NOTICE OF A TYPE II DECISION ON A PROPOSAL IN YOUR NEIGHBORHOOD

CASE FILE NUMBER: LU 06-171821 GW

Case Type: Greenway Review (GW)
Procedure: Type II, an administrative decision with appeal to the Hearings Officer

Proposal: The applicant proposes to develop a vacant 1.8 acre riverfront lot with a two-story building, parking and loading areas, and a dock. The dock is to be constructed of encapsulated foam and galvanized steel and aluminum, and is to be attached to 18-inch diameter steel pilings. The bank is also to be planted with native vegetation. Uses of the facility are identified as retail, vehicle repair, warehouse, and office.

- 4. Easement Documents
 - 5. Supplemental Narrative
- B. Zoning Map (attached)
- C. Plans/Drawings:
 - 1. Site Plan (Sheet A.1) (attached)
 - a. Overall Site Plan (3/5/2007 and 3/6/2007)

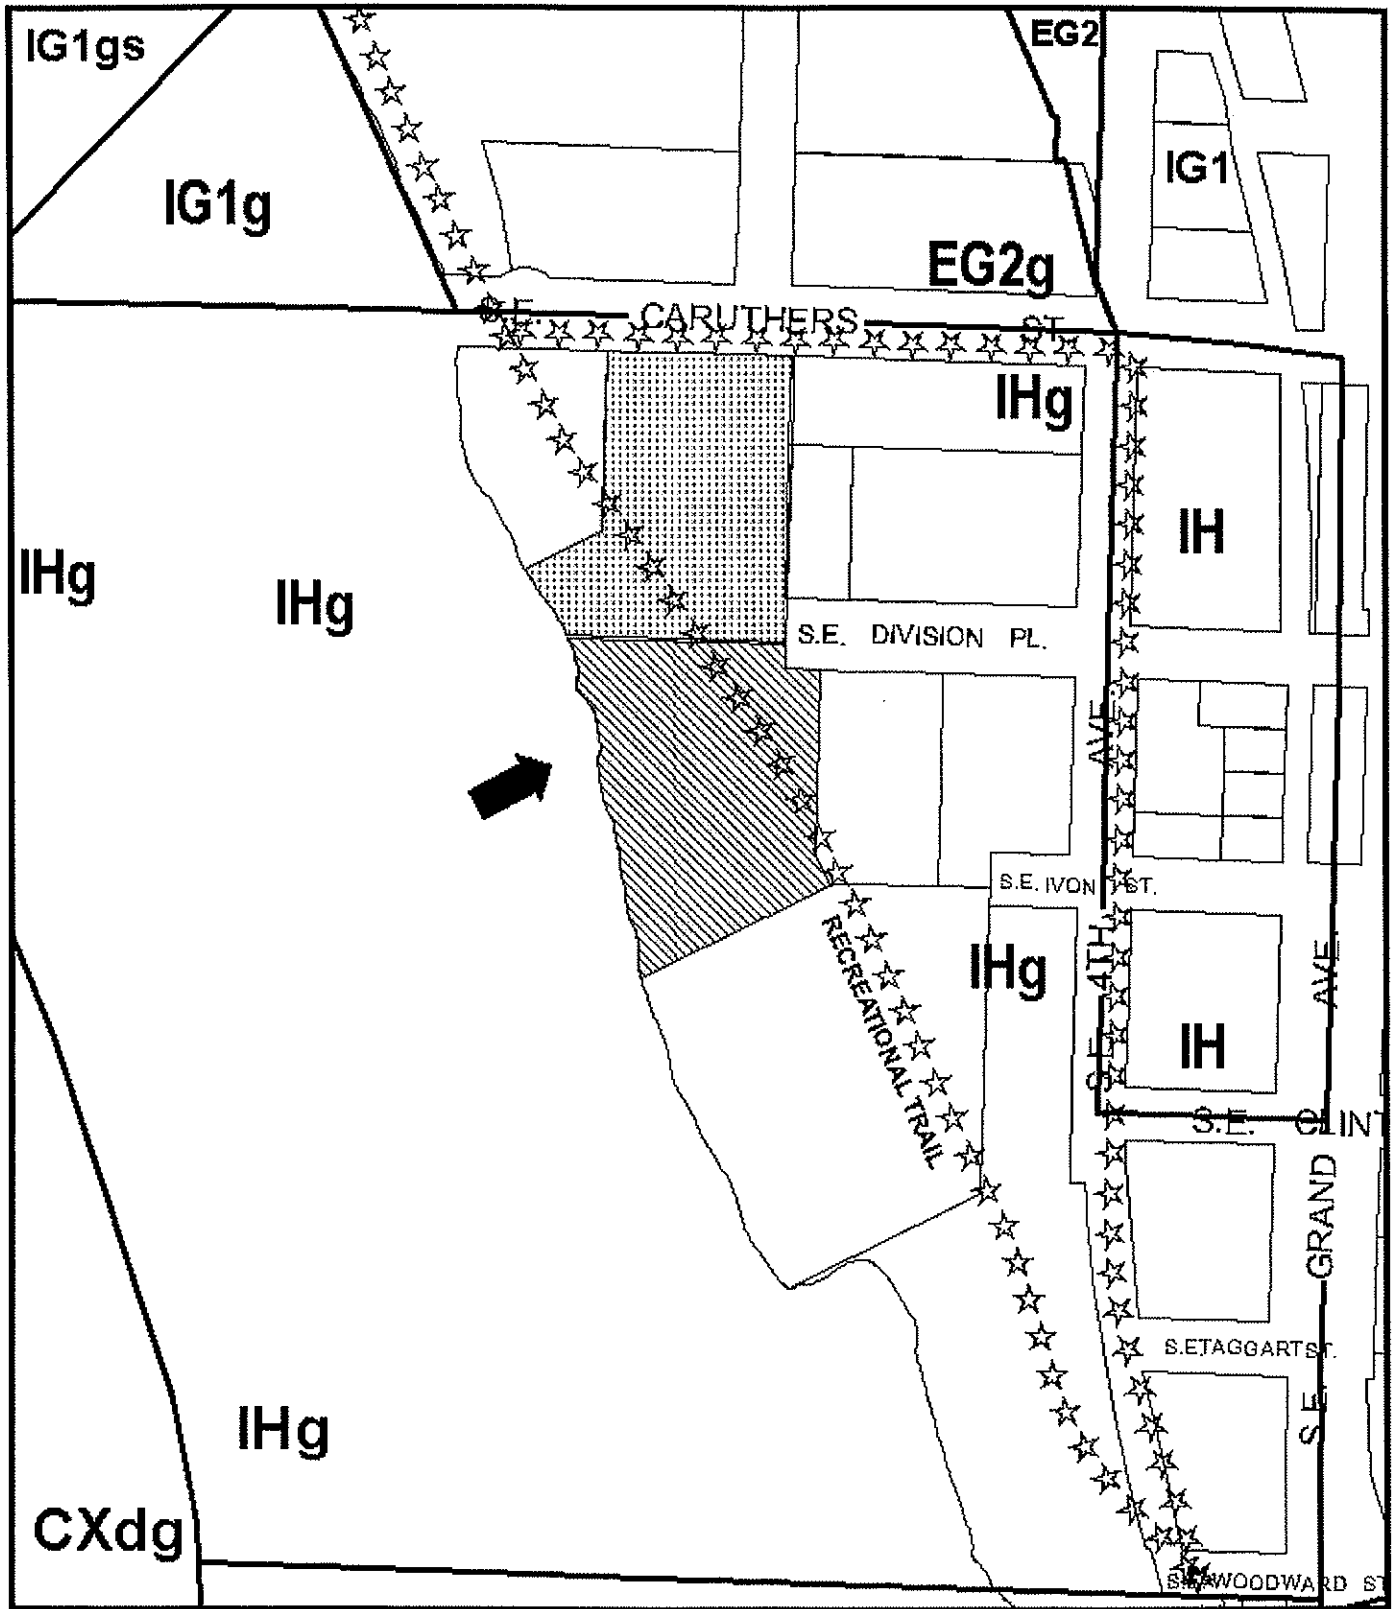
Response to Issue A: In order to assess if the location and design of the structures compliment the greenway setback it is necessary to first establish the location of the greenway setback itself. As noted in the discussion above, the proposed development plans (Exhibits C.1 and C.2) do not reflect the location of the greenway setback in accordance with the *Zoning Code* definitions, and would place the southwest corner of the building within the required greenway setback. The proposed building does not conform to the *Zoning Code* definition of *river-dependent* or *river-related* development; so all portions of the building must be located landward of the greenway setback. The proposed dock and ramp access, on the other hand, are *river-dependent* development and can be located within and riverward of the greenway setback, if approved through this Greenway Review.

However, without a plan that shows the building landward of the greenway setback, and that the exterior work area and gangway landing will be designed and installed to protect and preserve the trees riverward of the building and paved upland areas, the applicant has not demonstrated that the design and orientation of the development enhances the greenway setback. Furthermore, the plan does not include the greenway trail and access connections from the public right-of-way to the trail, though, as a note on the plan indicates, there is space to provide the greenway trail within the greenway setback. Given these deficiencies, the proposal does not meet this Issue.

also notes that access to the trail will be provided through opening in the perimeter chainlink (with a security deterrent top) fencing. However, no direct walkway connection or fence or gate openings are identified on the site plan (Exhibits A.1 and C.1). Plantings will be provided to screen the parking and exterior work areas from the greenway setback; however, plantings must also be provided to separate and screen the parking area from the pedestrian access route. No provisions for signs have been proposed to direct users to the access connection. With regard to access to the water's edge, the applicant has indicated that the proposed dock is only to be used by the employees of the facility, and that public access will not be allowed. Since the riverbank is relatively steep along the entire frontage, public access to the water's edge does not appear practical at this time.
